LONDON LUTON AIRPORT EXPANSION – DEADLINE 7 SUBMISSION

Project: London Luton Airport Expansion Development Consent Order

Stage Deadline 7 (9th January 2023)

Subject: National Highways position on 'Accounting for Covid-19 in Transport Modelling'
(TR020001/APP/8.148)

Figure 1. M1 Junction 10 Flows - 2043

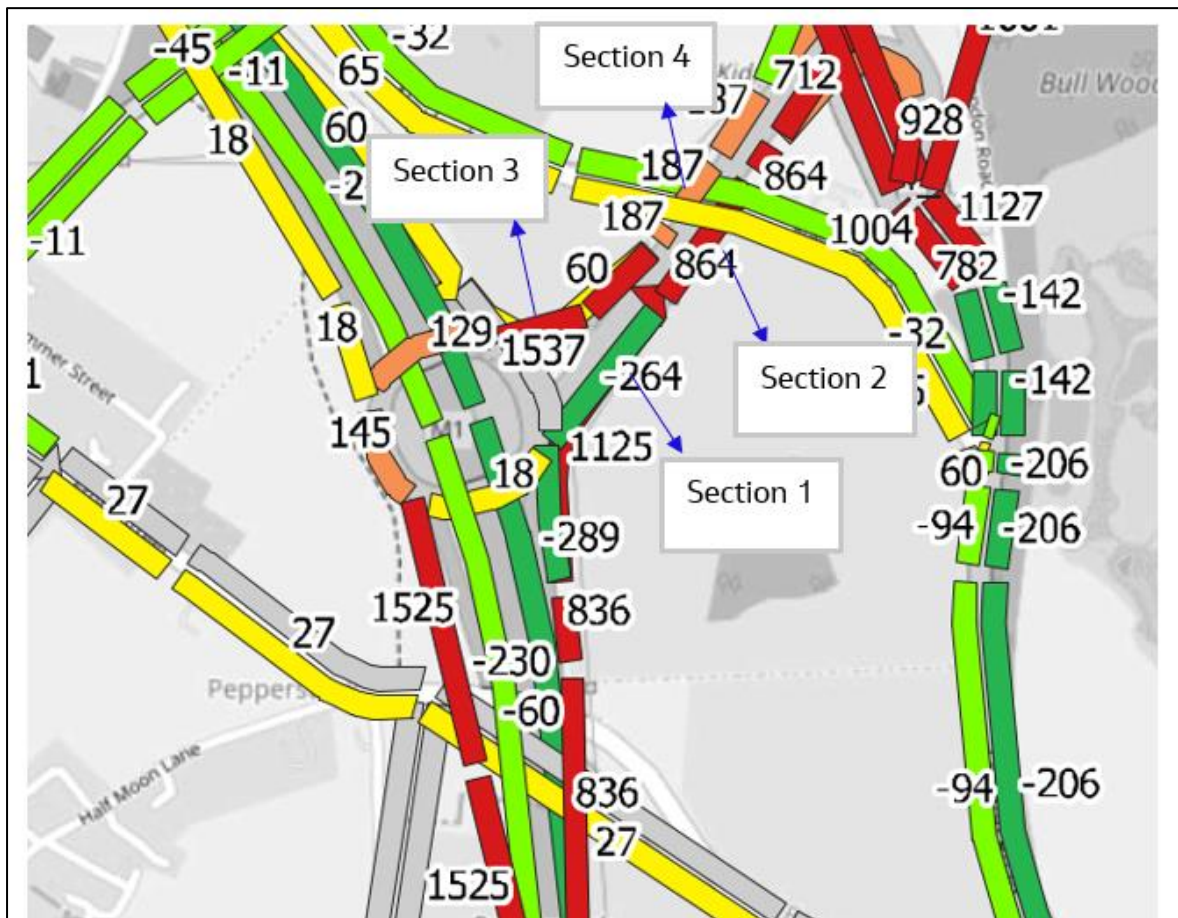
National Highways is concerned about the large differences in flows between with and without airport expansion in 2043 PM peak on the approach arm from the A1081. This could constrain the full traffic demand flow through to M1 junction 10 and result in a large queue on the A1081 approach to the junction during the PM peak period.

Figure 1 on the following page of this submission shows a breakdown of the coding sections of the approaches on the A1081 to M1 junction 10. In the network coding of the A1081 approach to the M1 junction 10, it is interpreted that the A1081 westbound has been represented in small segments in the strategic model with the very last link representing the start of the left-turn free-flow up to M1 junction 10 (section 1) and the link prior to this, representing the straight section of A1081 westbound (section 2).

The ACTMFR shows 2043 forecast year volume over capacity (V/C) ratios for M1 J10 (AM and PM peak periods) (Figure 4-11 in the ACTMFR). On the A1081 westbound, during the PM peak, the V/C ratio for the east right turn decreases from 49% without the airport expansion to 42% with the expansion. The corresponding figures for the east left turn free flow are 77% and 64% respectively.

However, looking at comparisons of traffic flow changes during the PM peak with and without the airport expansion (Figure 1 over the page), for section 1 on the A1081 westbound, the difference is -264 veh/hr and for the link immediately prior to this (section 2) the difference is +864 veh/hr. It is believed that the link V/C ratio as shown in the ACTMFR Table 4-11 relates to section 1 on A1081 rather than section 2.

Furthermore, Appendix F of the ACTMFR, shows the 2043 PM link V/C for A1081 westbound approach to M1 J10, and it indicates section 2 has a value between 80%-90% without the airport expansion and a value of between 90% -100% (ie reaching link capacity level) for the scenario with expansion.

There is a similar pattern and differences in the observed flows on the A1081 eastbound as indicated by sections 3 and 4 in Figure 1 below when compared to the V/C ratios in the ACTMFR Figure 4.1 1 and Appendix F.

An explanation is required on the reasons for the differences in the flows and V/C ratios on the SRN. Further, as indicated in Section 2.2 of this Technical Note, it is requested that the applicant provides further information on queues and delays on all sections of the A1081 approach to/from the M1 junction 10, to provide a more comprehensive understanding of traffic conditions on the approach to junction 10. Unless the provision of such information is deferred, National Highways are unable to determine the full development impact. The ExA will also require this information to inform its recommendation.

Figure 3 2043 PM M1 Northbound at South of VISSIM Model – 17:30

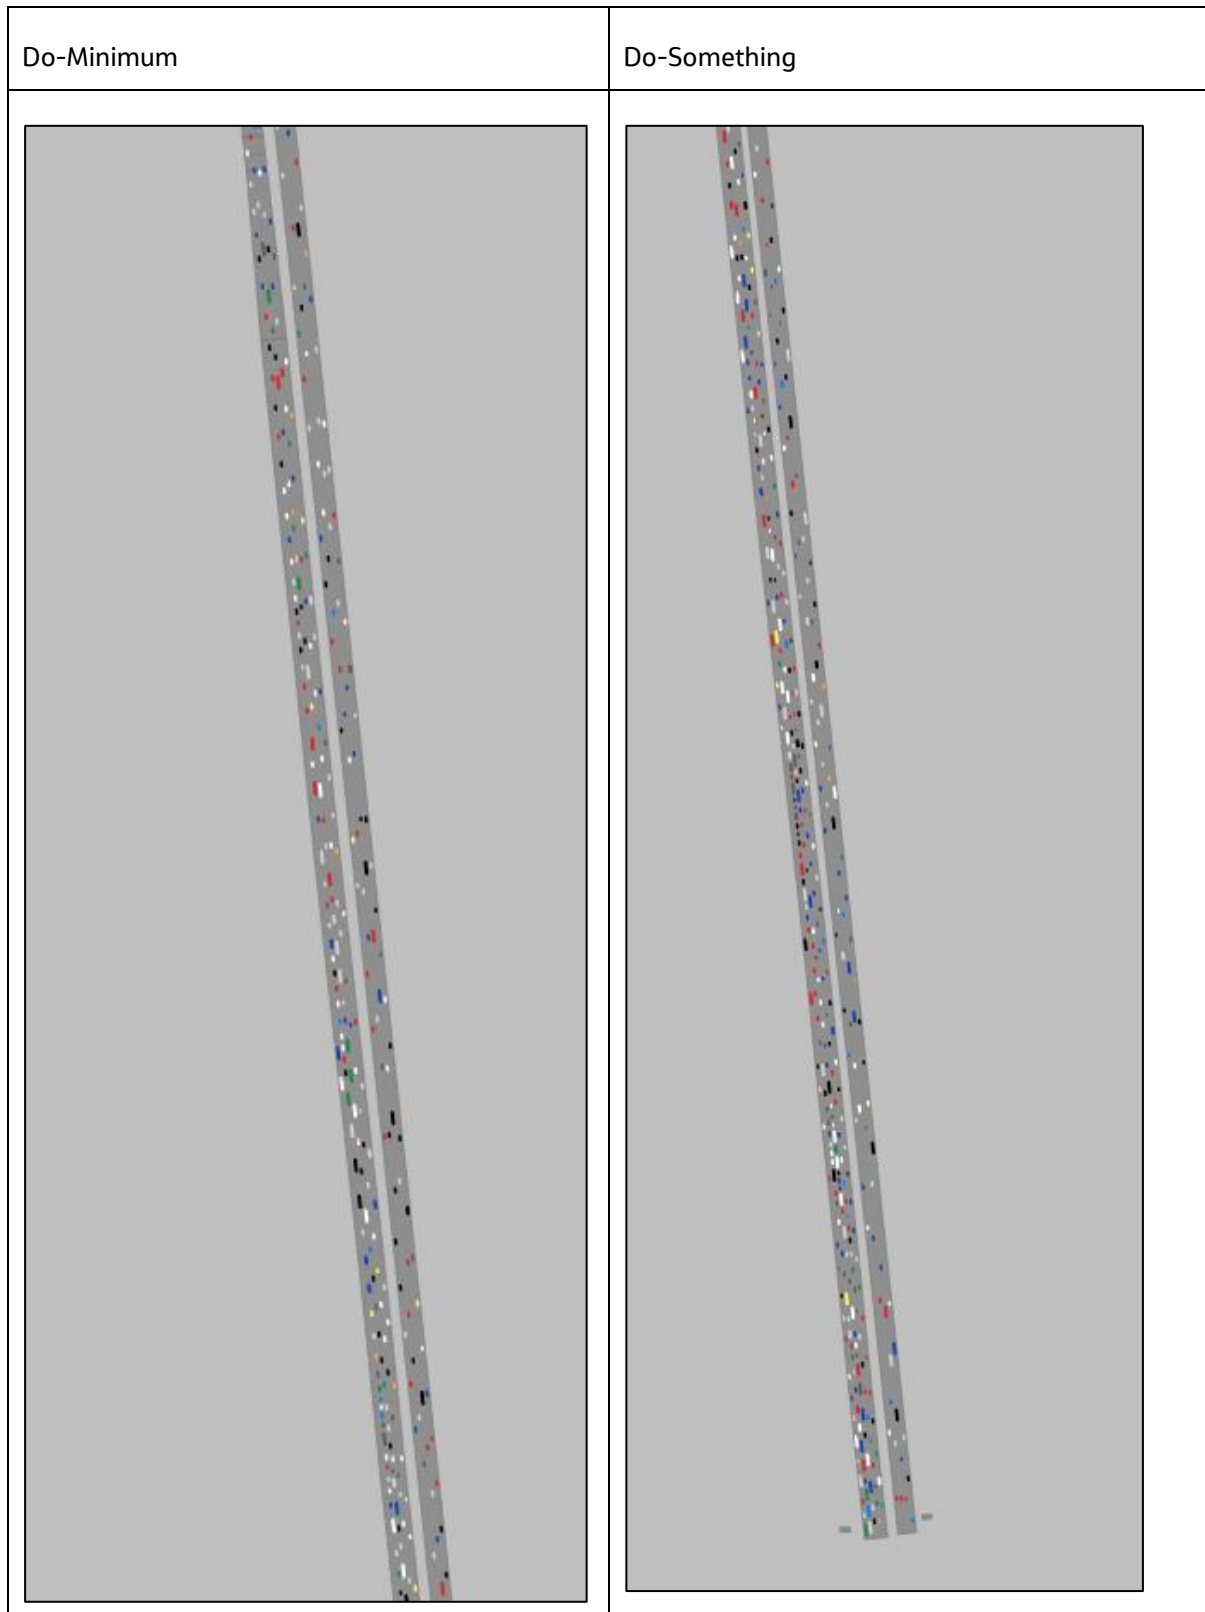
The VISSIM model screenshot in Figure 3 demonstrates that queuing still occurs at the lane drop on the northbound carriageway. The congestion at this location causes queuing that extends back to the southern edge of the network. As previously indicated it is not clear whether this is as a result of the development traffic or not as it is not possible to isolate the development traffic in the DM scenario.

Unless the provision of such information is deferred, the ExA will also require the information and explanations described above to inform its recommendation.

- Queuing still occurs at the lane drop on the northbound carriageway. The congestion at this location causes queuing that extends back on to the southern edge of the network. Therefore, National Highways position is that mitigation on the northbound diverge is still required as set out in National Highways submission at deadline 5 (REP5-093);
